## Arcola Elementary School Addition, Mandatory Referral, MR2014023

**SUBJECT:** Arcola Elementary School - Park/School Mandatory Referral – MR # 2014023

**SUBJECT:** Mandatory Referral No. 2014023  
 Arcola Elementary School Addition  
 1820 Franwall Avenue, Silver Spring  
 Kensington/Wheaton Policy Area

Attachment B – Interim Conditions - Construction Phase

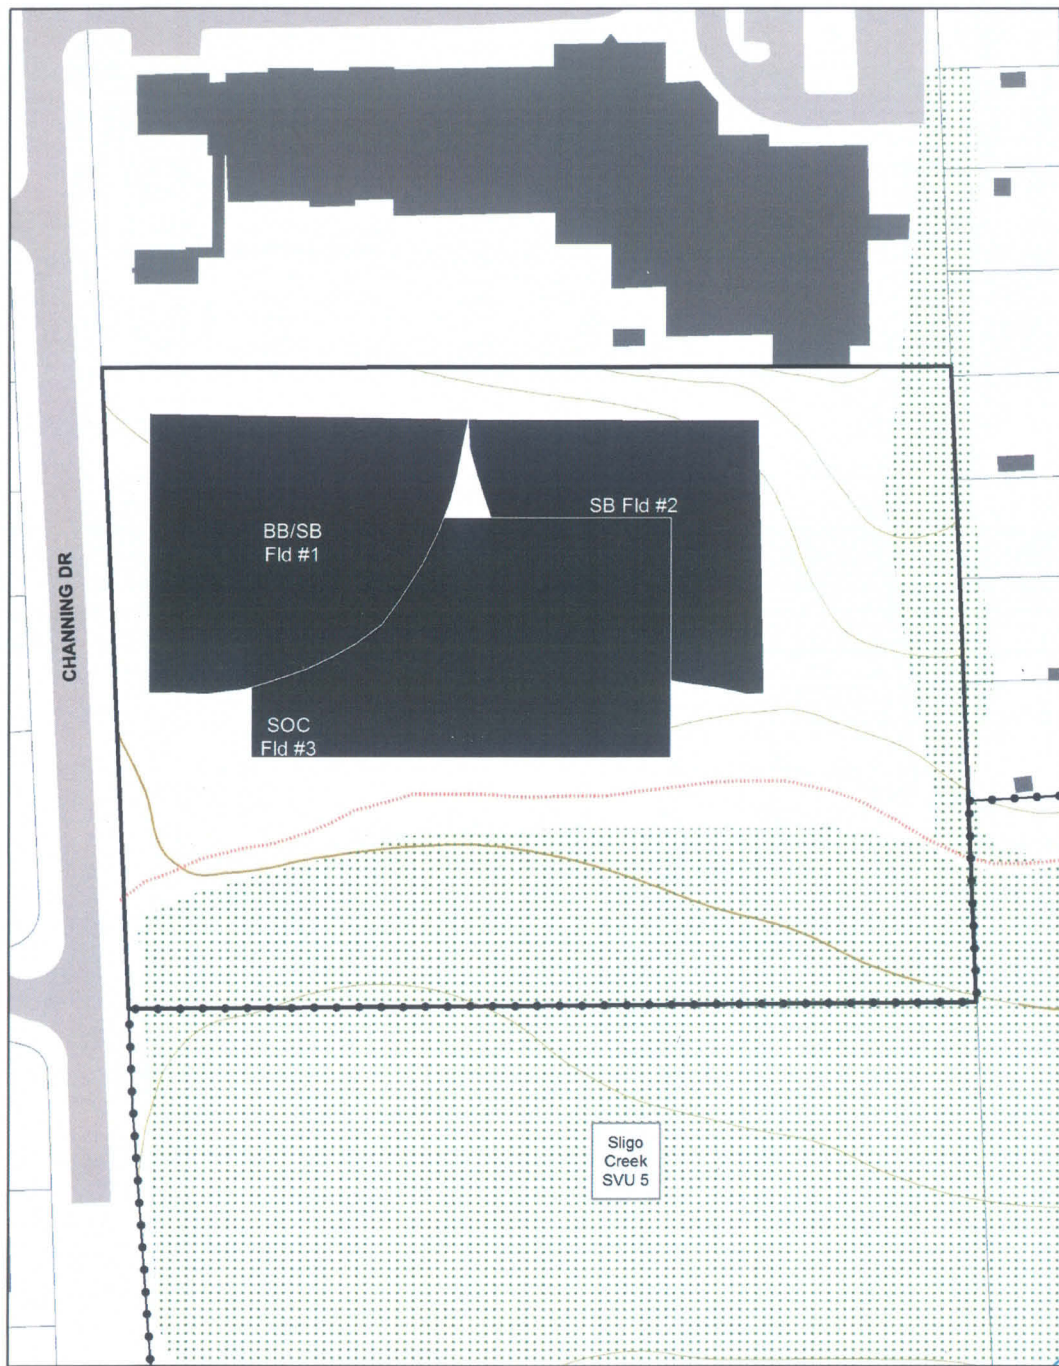
During the construction period, the Department of Parks proposes to give permission to Montgomery County Public Schools (MCPS), to close and fence Ballfield Number 1 to use as a secure construction staging area. MCPS will demolish the existing backstop, benches, and player protection fencing. Ballfield Number 2 will also be closed and demolished to allow a partially fenced, temporary recess area to include two pieces of playground equipment. The temporary recess area will be open to the public during non-school hours. Upon completion of school construction, all playground equipment will be removed and the site restored to a grass condition.

Community Use of Public Facilities (CUPF) will close the ballfields to permitting starting with the Spring 2014 season and will re-open for the Spring 2016 season. The closure duration period is due to a combination of construction and field restoration activities. Non-permitted community use will be allowed during construction outside the fenced staging area. **(See Attachment B).**

Montgomery County Public Schools (MCPS) will establish a temporary construction staging area on the site of Ballfield Number 1. The staging area includes a temporary construction and maintenance access for stockpiling, construction trailer and construction worker parking. The backstop, player benches and player protection fencing will be removed. The staging area will be fenced and NO windscreen will be installed to ensure site visibility and security. The staging area will commence January of 2014 and end August of 2015. MCPS is responsible for all maintenance such that a construction staging area requires. Sodding and field restoration will begin November of 2015.

Due to construction activity and student safety, MCPS will establish a temporary fenced recess area on Ballfield Number 2. MCPS will demolish the existing backstop, benches, and player protection fencing. MCPS will then sod all disturbed areas. MCPS will install two pieces of temporary playground equipment inside a mulch bed within the fenced area. The temporary playground equipment will be used from Spring of 2014 through August of 2015. The temporary playground equipment will be removed and the playground footprint re-sodded November of 2015 concurrent with staging area sodding and Ballfield Number 1 restoration. The playground will be fenced with no windscreen to ensure visibility. MCPS is responsible for all maintenance such that a fenced temporary recess area requires. The Department of Parks reserves the right to inspect the playground at the usual interval as if the playground was permanently installed in the park.

Attachment C – Final Site Configuration

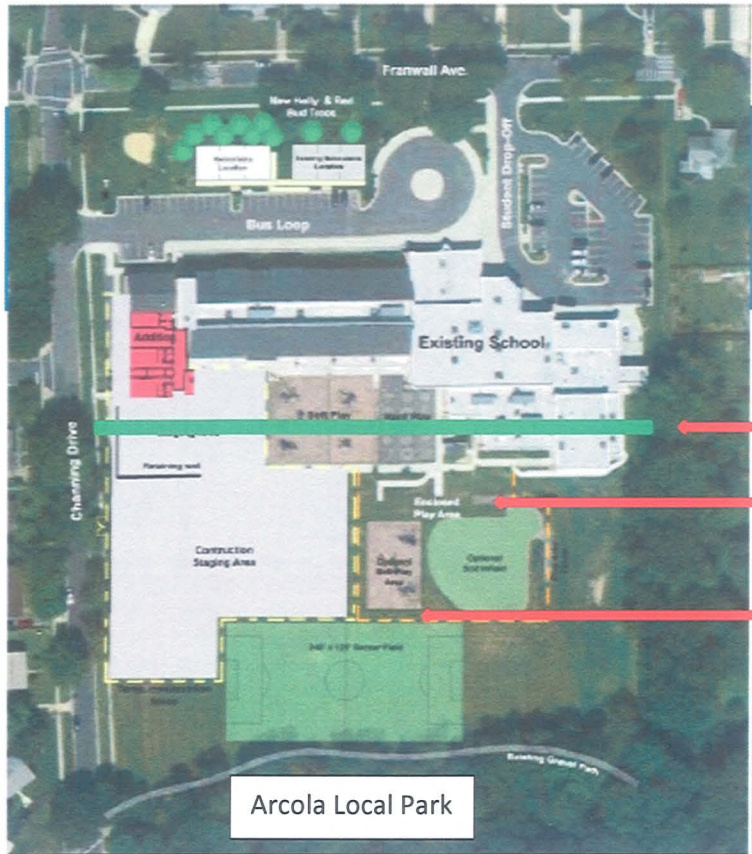
When the school project is completed, Ballfield Number 1 will be completely rebuilt and made ADA-compliant and Ballfield Number 2 will be eliminated to create more green space for a variety of activities. This will allow Parks to restripe the rectangular field in a variety of configurations to meet field demands in the area. In addition, all the temporary recess-related playground equipment removed. **(See Attachment C).**

Ballfield Number 1 will be rebuilt as a skinned infield to Park standards and made ADA-compliant. In addition, backstop replacement, player benches, player protection fencing will be replaced, and infield mix specification will be determined during the Park Construction Permit review. The balance of restored staging area/Ballfield Number 1 will be sodded.
